Petition No. 0263

REQUEST ENCROACHMENT INTO PETERBORO AT 830 PETERBORO ST. (With Stairs, Hardscape, Egress Wells, 3rd Floor Balcony and Fencing)

CITY OF DETROIT CITY ENGINEERING DEPARTMENT SURVEY BUREAU					
DRWG. NO.	X 263

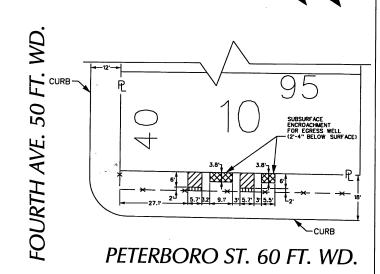
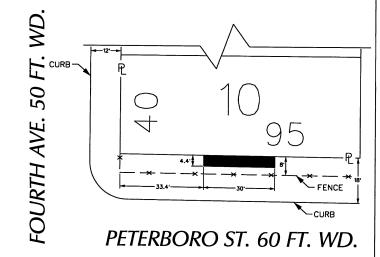
(X) Involved; have no objection to the requested encroachment into Peterboro at 830 Peterboro St. (with Stairs, Hardscape, Egress Wells, 3rd Floor Balcony and Fencing) as shown on drawing no. x0263 dated 9/17/2018 provided that a minimum 6 ft wide clear unobstructed sidewalk shall be maintained for pedestrian traffic at all times.
